Re: Proposed Changes to the Bay Delta Conservation Plan/California WaterFix Continue to Threaten the Delta, Time for Plan "B"

Proposed Changes to BDCP/Cal. WaterFix Continue to Threaten Delta, Time for Plan "B"

Contra Costa County Comments on WaterFix RDEIR/SDEIS**General Comment on the Inadequacy of All BDCP Alternatives**

Figure B-1: Daily EC values at Barker Slough from the sensitivity analyses for the period October 1976 through September 1984.

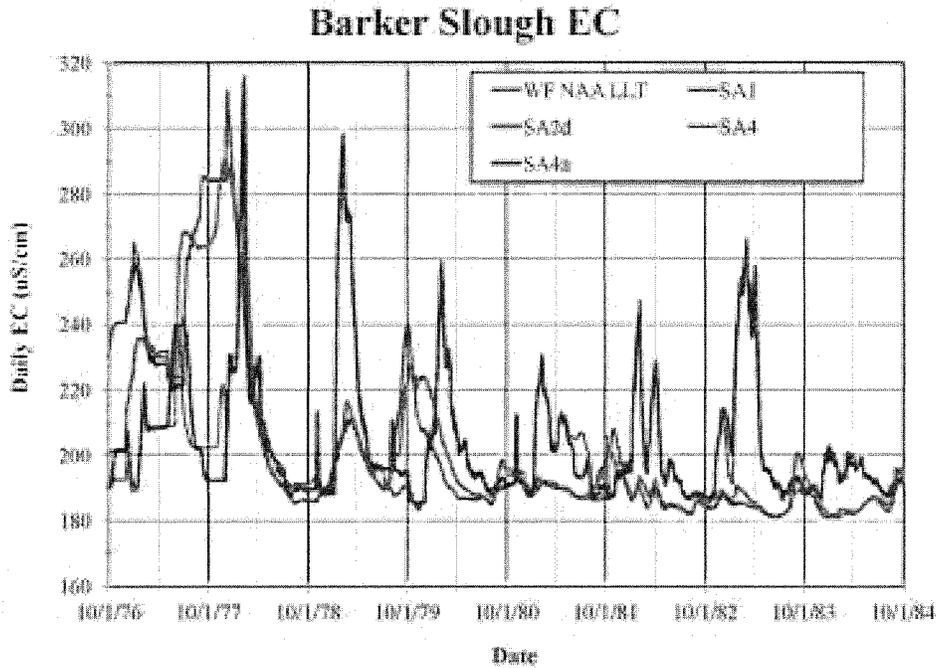
As shown in Figure B-1 and Figure B-2, removing the 65,000 acres of habitat restoration could reduce EC at Barker Slough during drought periods (relative to the BDCP Draft EIR/EIS proposed project, SA1) but increases EC significantly in normal and wetter years.

Figure B-3: Scatter plot of daily EC values at Barker Slough from the WaterFix sensitivity analyses with no restoration (SA4a, LLT) for the period October 1975 through September 1991. Some peak EC are reduced relative to the No Action equivalent but significant adverse impacts occur at other times.

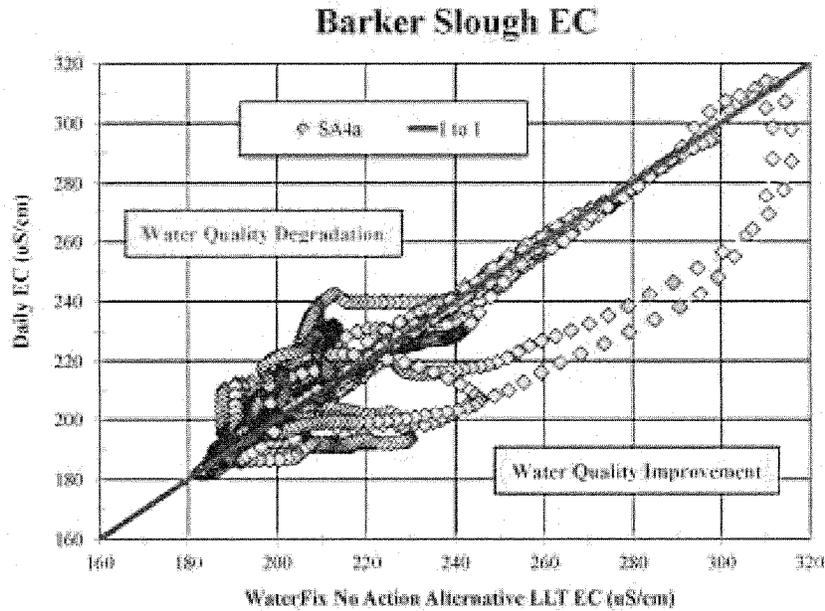
Figures B-3 and B-4 show the EC data for each month of the 16-year sensitivity analysis simulation period (192 data points) in the form of scatter plots. The EC data for Barker Slough and Belden's Landing for Sensitivity Analysis #4 (no habitat restoration) are plotted as a function of the WaterFix No Action Alternative and both are at late long term.

Some peak ECs at Barker Slough are reduced relative to the No Action equivalent but significant adverse impacts occur at other times. There are some reductions in EC relative to the No Action equivalent at Belden's Landing but significant adverse impacts occur at other times. The presentation of water quality data must present the data in sufficient detail to fully disclose the daily or month to month variations in water quality, in particular the occasions when salinities increase significantly. It is not acceptable to only present long-term averages that obscure and reduce the significant impacts on urban and agricultural water users, and the Delta ecosystem.

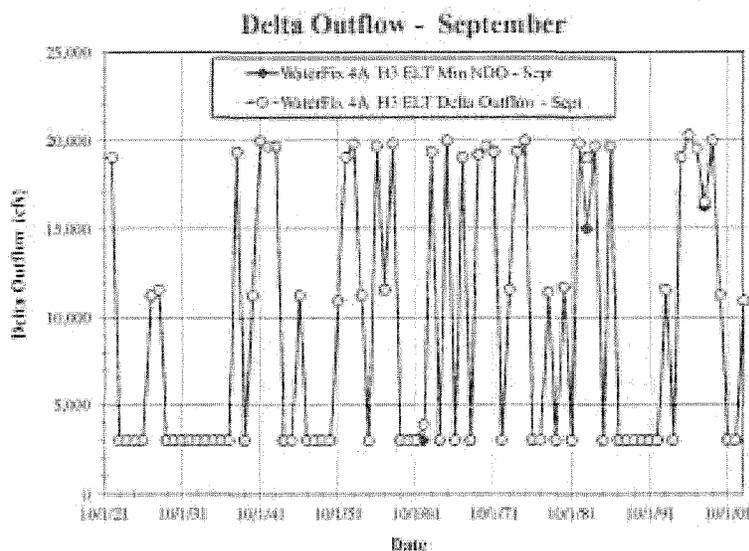
The outflows required to meet the Fall X2 requirement in September and October in the WaterFix analyses using CALSIM II, however, are very much larger. As shown in Figure B-5, the assumed minimum Delta outflows to meet X2 at Mallard Island (in wet years) and Collinsville (above normal years) are about 19,500 cfs and 11,500 cfs, respectively. These flows seem to be too high and may be artificially freshening the Delta during September and underestimating the water quality impacts of the proposed project. The reason for these high flows may be because the CALSIM II only attempts to meet September X2 requirements at the last minute, whereas increasing Delta outflows earlier will require much less Delta outflow.

A new Draft EIR/EIS must be prepared that corrects or justifies through detailed modeling and detailed data presentations, the apparent excessive Delta outflows in both September and October which cause water quality impacts to be under predicted. The new Draft EIR/EIS must then be released for public review and comment.

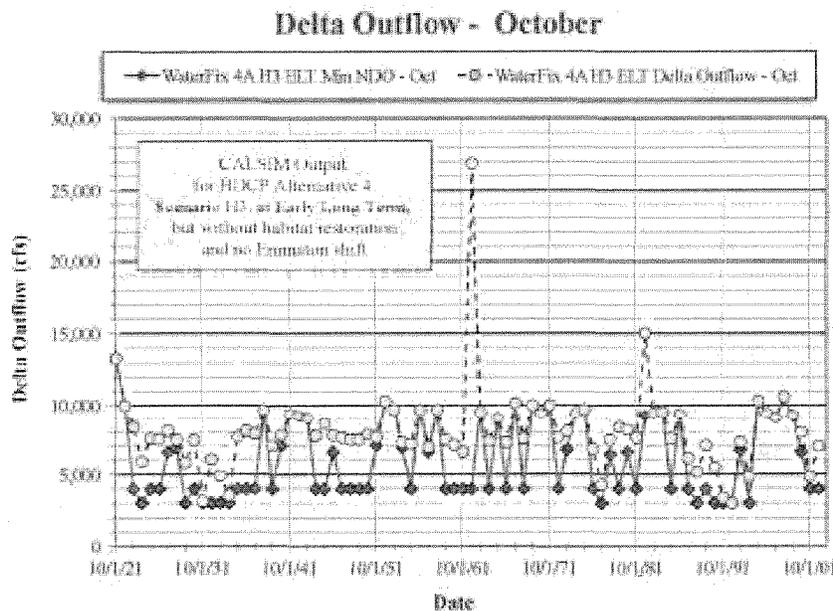
Figure B-6 shows in the corresponding Delta outflows and minimum required Delta outflows for October. The October outflows are governed by the need to meet Fall X2 in wet and above normal years. Otherwise the D-1641 requirement of 3,000 cfs in critical years and 4,000 cfs in other water years applies. The flows assumed to be required to meet Fall X2 are consistent with the existing X2 outflow requirements. However, excess Delta outflows are occurring in many below normal, dry and critical years, which may underestimate the actual water quality impacts of the proposed project.

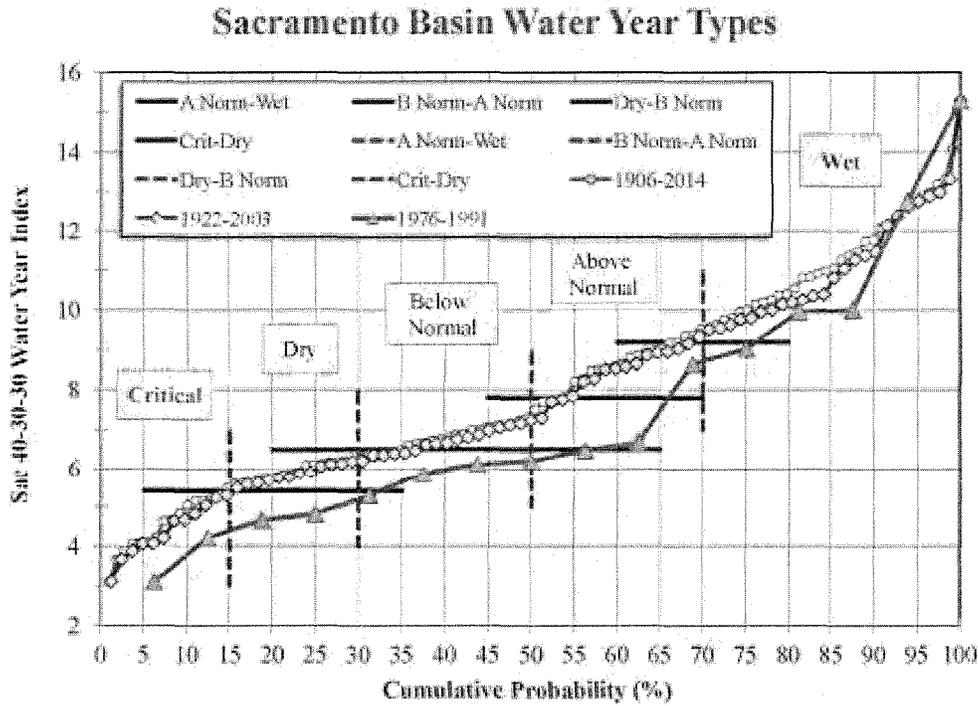
The water quality analyses are only performed and presented for the period October 1975 through September 1991 (16 years). This period contains two major droughts (1976-1977 and 1987-1991) but only the latter is used to represent the water quality changes under drought conditions. When the data are categorized by month and by water year type, the amount of data available to be averaged can be as few as 2-5 months of data. That is not sufficient data to develop a statistically significant representation of the variations by month and water year type.

Also as shown in Figure B-7, the water year 1976-1991 period is considerably drier than the full historical record (1906-2014) and the 1922-2003 period used for the Central Valley operations modeling using CALSIM II.

Figure C-1: Monthly total Delta exports as a function of Delta outflow for the WaterFix preferred alternative (Alternative 4A, Scenario H3 at Early Long Term). Only months when outflows are less than 30,000 cfs are plotted.

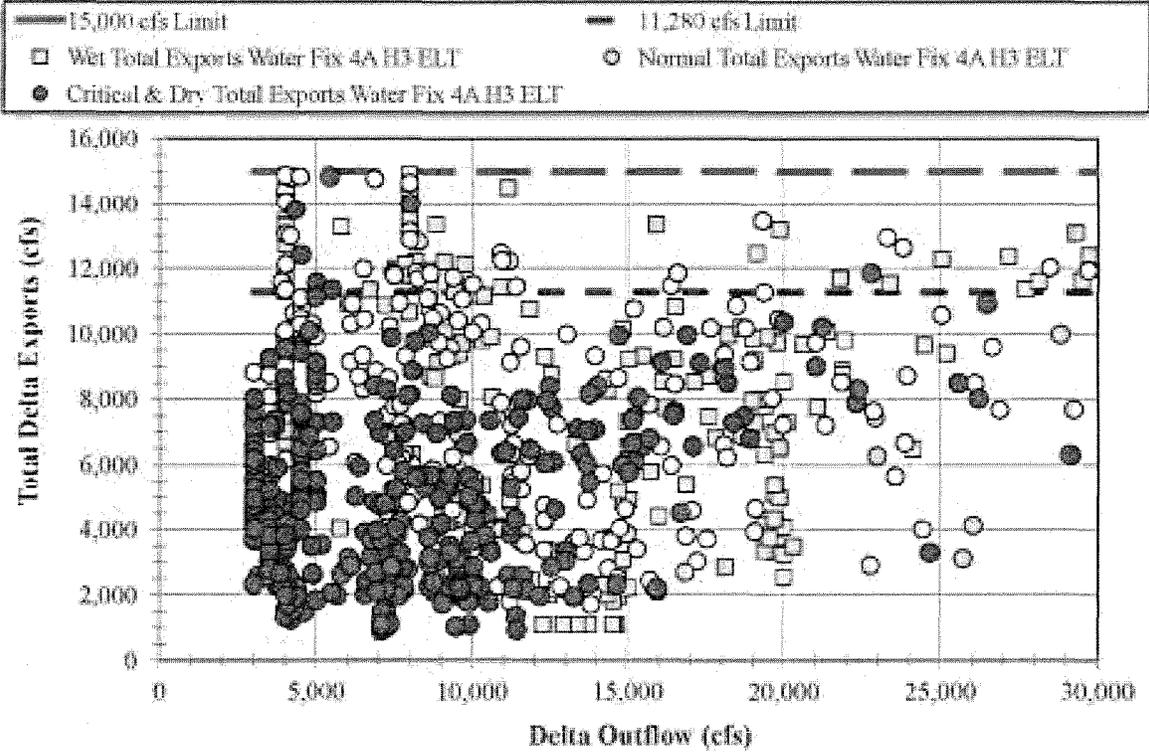
Currently, the maximum rate of exports from the Delta during drier periods is about 11,280 cubic feet per second (6,680 cfs at the SWP export facility plus 4,600 cfs at the CVP pumps.). As shown in Figure C-1, the WaterFix data for Alternative 4A, Scenario H3 at early long term, suggest that in many dry months when Delta outflows are very low, the combined SWP and CVP exports from the south Delta would be as high as 14,900 cfs. This is an increase in south Delta pumping of 3,600 cfs or about 24%.

Rather than diverting less in dry periods and reducing the CVP and SWP’s dependence on water from the Delta, the WaterFix project would increase exports.

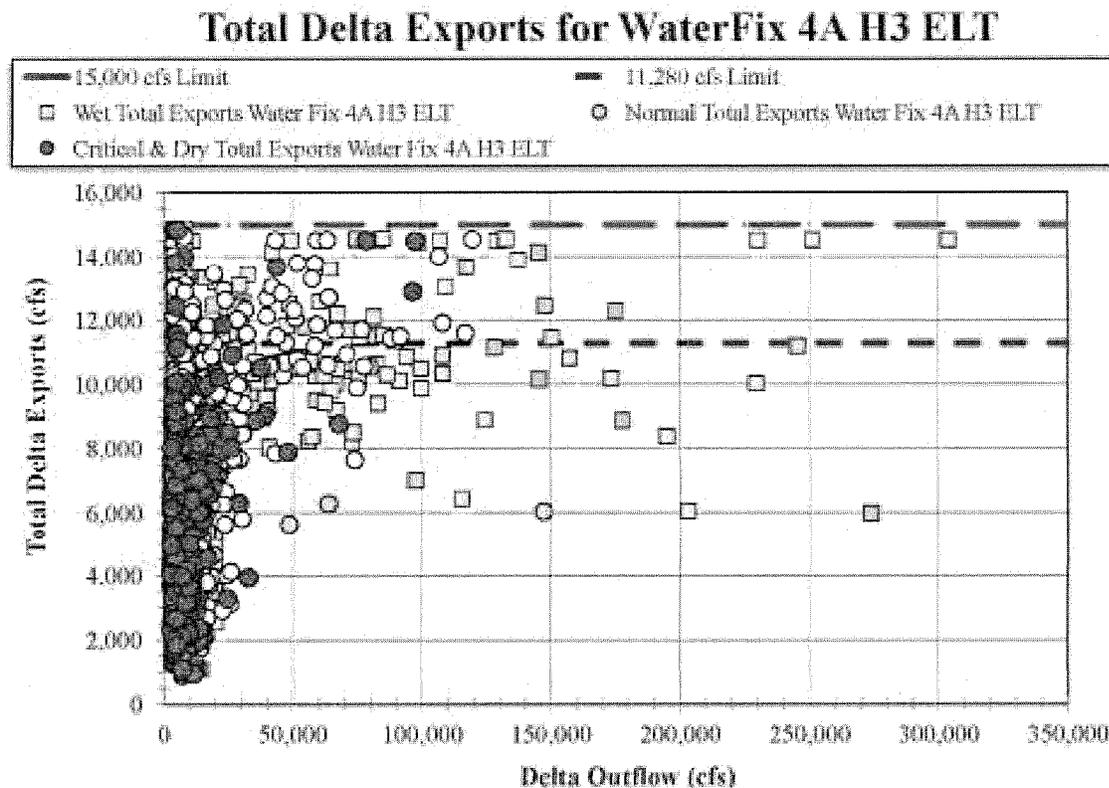
The same WaterFix operations simulations show that during periods of high Delta outflow (say 30,000 cfs or greater), when water surplus to the needs of the Delta could be available for export, the WaterFix preferred alternative often fails to increase in export diversions above existing levels (Figure C-2). In other words, without new storage in or close to the Delta, the WaterFix preferred alternative is unable to capture this surplus flow. During wet periods, farmers’ fields and urban landscapes are soaked reducing demand for water. The existing south-of-Delta reservoirs fill and there is nowhere else to quickly store the more water. The WaterFix preferred alternative will be unable to regularly take a “Big Gulp.”

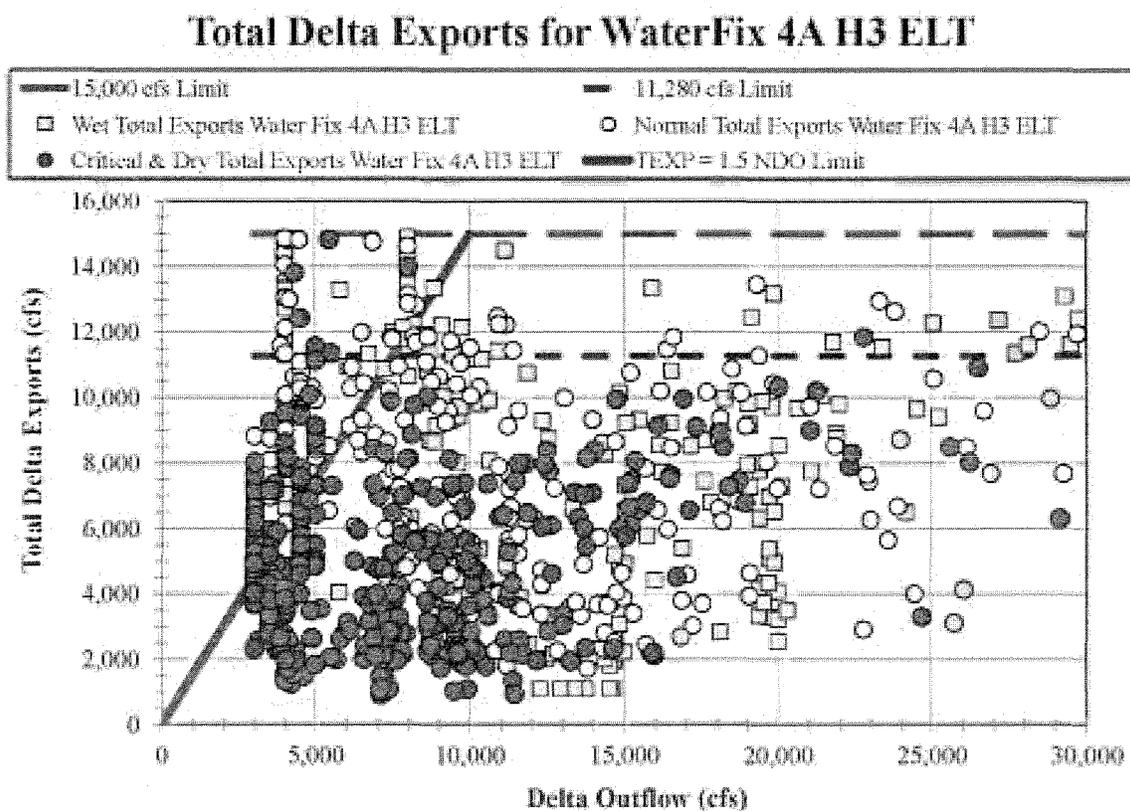
Figure C-3 shows the same data as Figure C-1 but this figure also shows a limit on total CVP and SWP exports of the form: total exports = 1.5 x Delta outflow.

This would mean that in the fall when outflows are only 3,000 cfs, only 4,500 cfs can be exported. The CVP and SWP would not be able to increase exports above existing levels unless Delta outflow was 7,500 cfs or greater. The resulting loss of export water would have to be made up during periods of higher Delta outflow. That will not be possible though without new storage and other infrastructure in the Delta to capture more water during higher flow periods.

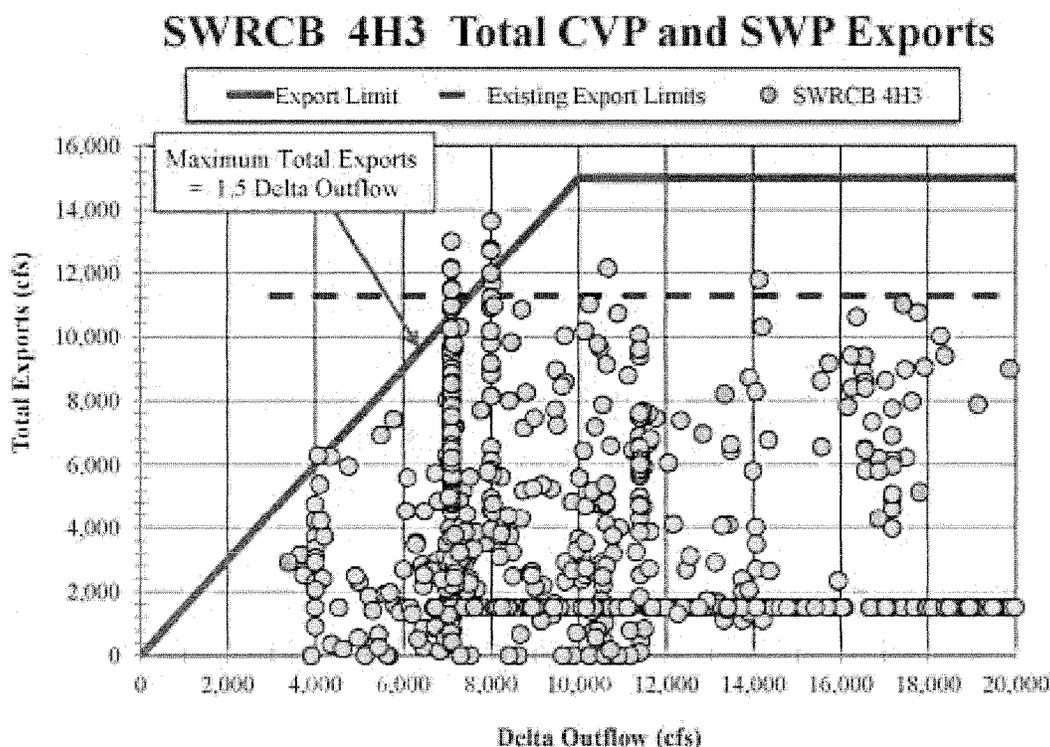
requirements specified by the SWRCB. Unfortunately, DWR and Reclamation did not modify the WaterFix infrastructure to adapt to these higher outflow requirements so the environmental benefits and viability (with respect to cost and water supply benefits) of a higher Delta flow alternative were not tested and disclosed. It is interesting, however, that the corresponding total exports versus Delta outflow graph for SWRCB Alternative 4H3 shown in Figure C-3 does represent less water being exported in drier periods. The reduced exports in this SWRCB alternative are consistent with the suggested low outflow export limit (total exports = 1.5 x Delta outflow).

A new Draft EIR/EIS should be prepared that includes more holistic alternatives that reduce exports during drier months (e.g., in a fashion similar to the suggested exports = 1.5 inflow limit) and are able to capture “new” water during periods of high Delta outflow. That would contribute to achieving the coequal goals as well as improving water quality in the Delta. The dismal WaterFix proposal hinders any progress to achieving these goals. The new Draft EIR/EIS should then be released for public review and comment.

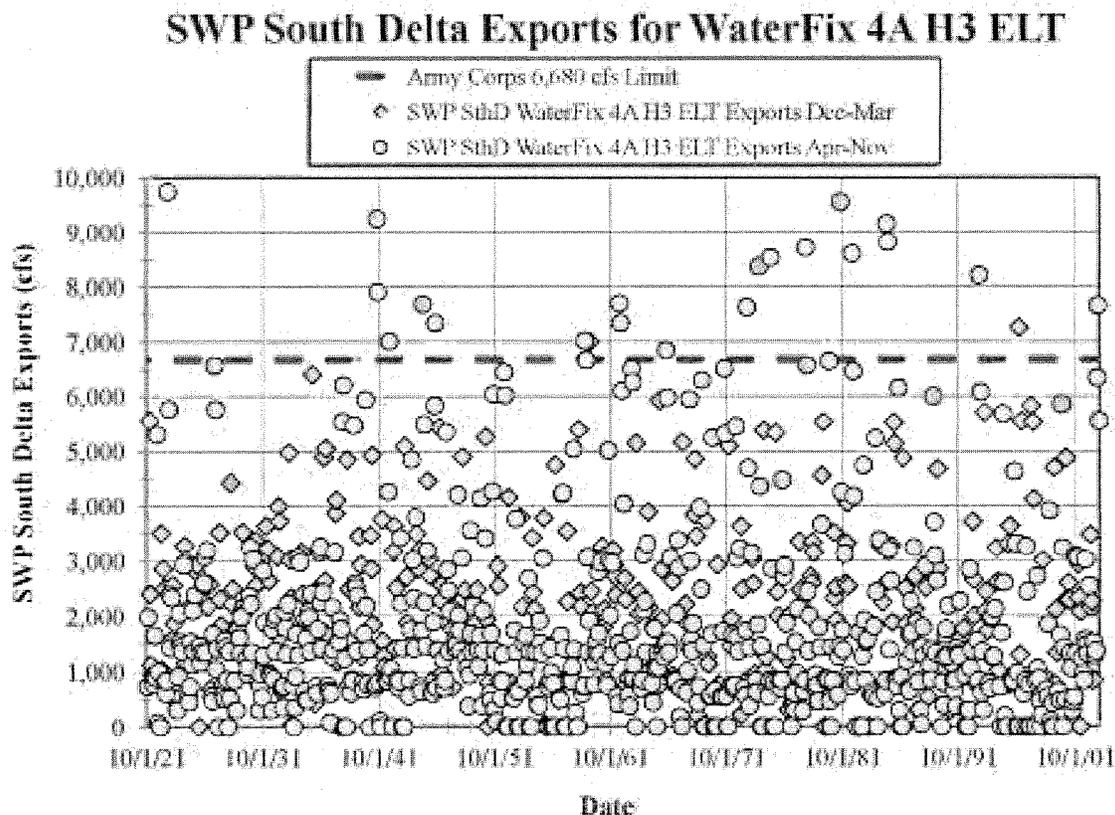
Figure C-5 shows the WaterFix analysis SWP South Delta export data for Alternative 4A, Scenario H3, at early long term, for April through November when the Army Corps limits of 6,680 cfs apply. The simulated inflows to Clifton Court (SWP through-Delta exports) are as high as 9,750 cfs with total south Delta export as high as 14,350 cfs. This is well in excess of the permitted values for this period, and is inconsistent with the WaterFix project claim of ecosystem benefits because exports from the south Delta will be reduced.

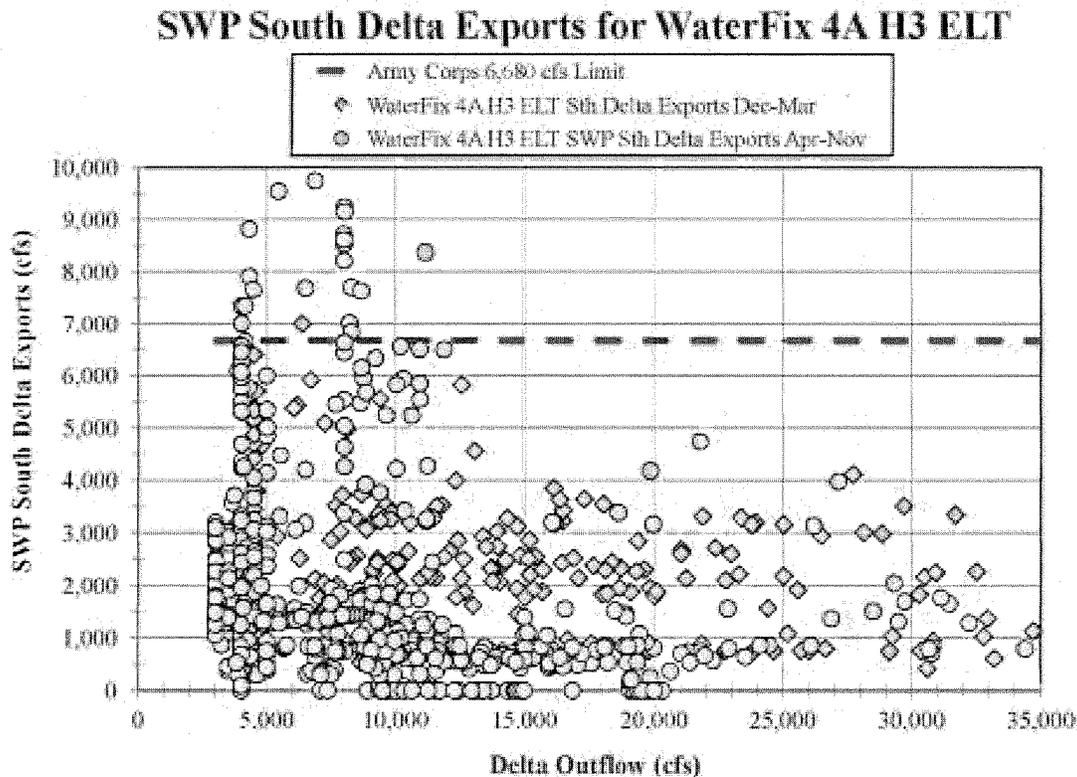
Figure C-6 shows the same SWP south Delta export data as Figure C-5, but this time plotted as a function of Delta outflow. The violations of the Army Corps limits occur during drier months when Delta outflows are lower. This is again directly contrary to the principle of taking a “Little Sip” during drier periods, *i.e.*, reducing exports relative to existing levels.

A new Draft EIR/EIS must be prepared that includes new alternatives that comply with the U.S. Army Corps of Engineers limits on inflow to Clifton Court Forebay, and other legal requirements set by the SWRCB and the biological opinion, and released for public review and comment.

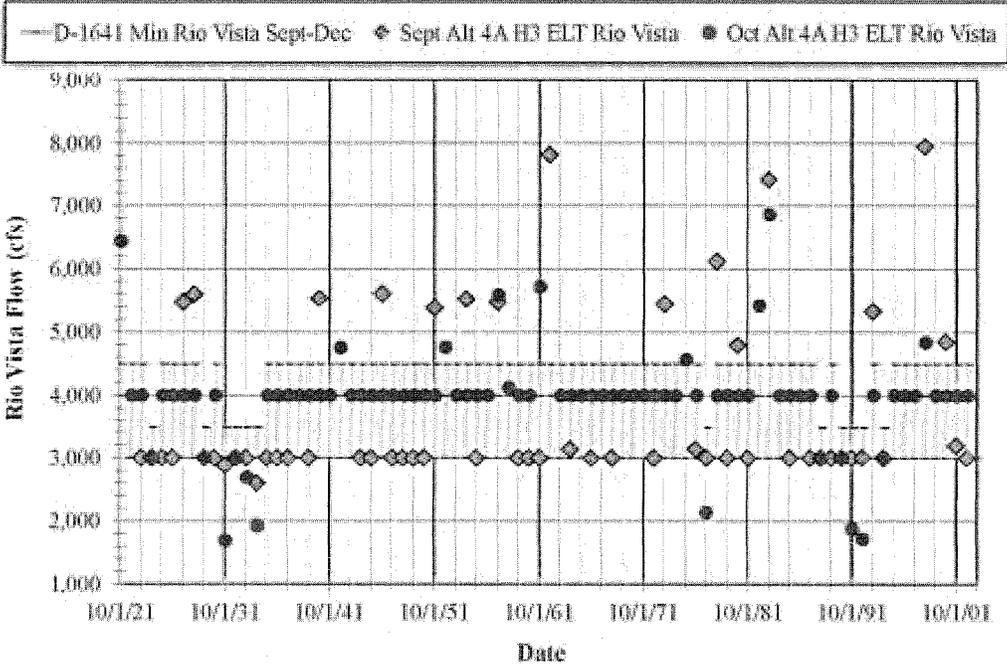
SWRCB Water Rights Decision 1641 requires minimum Rio Vista flows be met in the fall (September through December). As shown in Figure C-7, the monthly Rio Vista flows for September and October for the WaterFix preferred alternative (Alternative 4A, Scenario H3 at Early Long Term) fall well below the D-1641 requirements in a number of the drier years.

The WaterFix RDEIR/SDEIS is inadequate because it fails to comply with the SWRCB minimum flow requirements at Rio Vista and fails to clearly disclose these significant violations to decision makers and the public. A new Draft EIR/EIS must be prepared which includes new alternatives that comply with all legal requirements including the Rio Vista minimum flow standards and then be released for public review and comment.
